SUNDRY NOTICES AND REPORTS ON WELLS

1. Type of Well ☒ Oil Well ☐ Gas Well ☐ Other		5. Lease Serial No. LC-028772-b NM 54184
2. Name of Operator OXY USA Inc. 16696		6. If Indian, Allottee or Tribe Name
3a. Address P.O. Box 50250 Midland, TX 79710	3b. Phone No. (include area code) 432-685-5717	7. If Unit or CA/Agreement, Name and/or No.
4. Location of Well (Footage, Sec., T., R., M., or Survey Description) 990 FSL 990 FWL SWSW (M) Sec 11 T18S R28E		8. Well Name and No. Dunn Federal #3
		9. API Well No. 30-015-10622
		10. Field and Pool, or Exploratory Area Artesia QUGB SA
		11. County or Parish, State Eddy NM

OXY USA Inc. - Proposed
Dunn Federal #3
API No. 30-015-10622

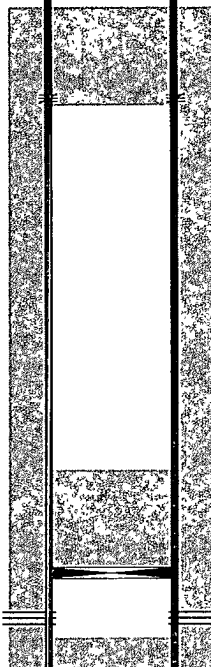
1. RIH & Set CIBP @ 2480' spot 30sx cmt to 2355'
2. Perf @ ~~1805'~~ sqz 45sx cmt to ~~1685'~~ WOC-Tag Perf @ 1854 sqz to 1734'
3. Perf @ ~~550'~~ sqz 175sx cmt to Surface Perf @ 730 sqz to surf
10# MLF between plugs
4. At cut-off fill all annulus to surf

③ Perforate @ 730 SQZ
cmt to Surf

② Perforate @ 1854 SQZ
cmt to 1734 WOC Tag
